Access Compliance Report

Public Rights-of-Way

(Curb Ramps)

Intersection ID: 14765	Main Street: BONNYBROOK_LN	Cross Street: FARM_POND_LN	Location: SE
ADA ID: 5D9C5B450171	Ramp Type: Directional1	Initial Pass/Fail: Fail	Overall Compliance: No
Severity Score: 21.25			
Codes/Mitigation Info/Possible Solution		Field Measurements/Component Compliance

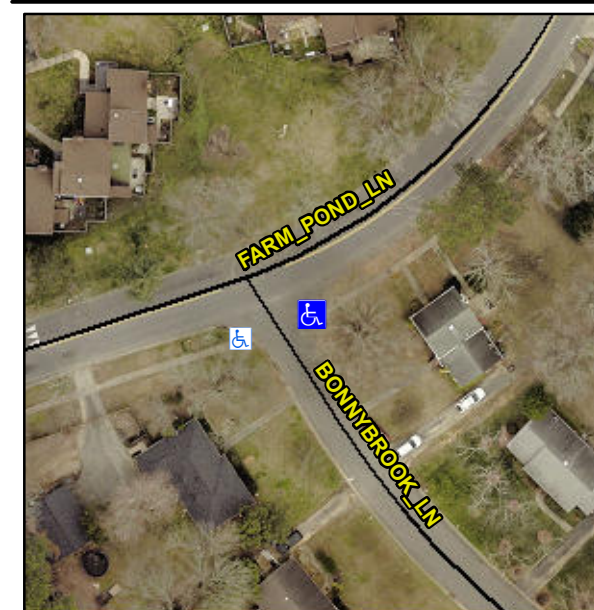
R304.5.1, R304.5.3

Compliance	Description	Data	Compliance	Description	Data
N/A	Ramp Length (in)	72.0	N/A	Grade Break?	N/A
No	Ramp Width (in)	39.0	N/A	Grade Break Slope (%)	0.0
Yes	Ramp Slope (%)	6.0	N/A	Grade Break XSlope (%)	0.0
No	Ramp XSlope (%)	5.3			
N/A	Flare Type LT	N/A	N/A	Flare Type RT	N/A
N/A	Flare Slope LT (%)	N/A	N/A	Flare Slope RT (%)	0.0
N/A	Flare Traversable LT?	N/A	N/A	Flare Traversable RT?	N/A
N/A	Landing Length (in)	0.0	N/A	DWS Provided?	N/A
N/A	Landing Width (in)	0.0	N/A	DWS Contrast?	N/A
N/A	Landing Slope (%)	0.0	N/A	DWS Length (in)	N/A
N/A	Landing X Slope (%)	0.0	N/A	DWS Full Width?	N/A
N/A	Landing Curb? (Y/N)	N/A	N/A	DWS Offset LT (in)	N/A
N/A	Shared Landing?	N/A	N/A	DWS Offset RT (in)	N/A
N/A	Gutter Ponding?	0.0	N/A	Gutter Slope (%)	N/A
N/A	Gutter Lip Ht (in)	0.0	N/A	Gutter X Slope (%)	N/A
N/A	Painted X Walk1?	No		Road Slope (%)	2.1
	X Walk 1 Direction	To W		Road X Slope (%)	0.7
	X Walk 1 Width (in)	N/A		Clear Space?	N/A

Remove & Replace Entire Ramp.
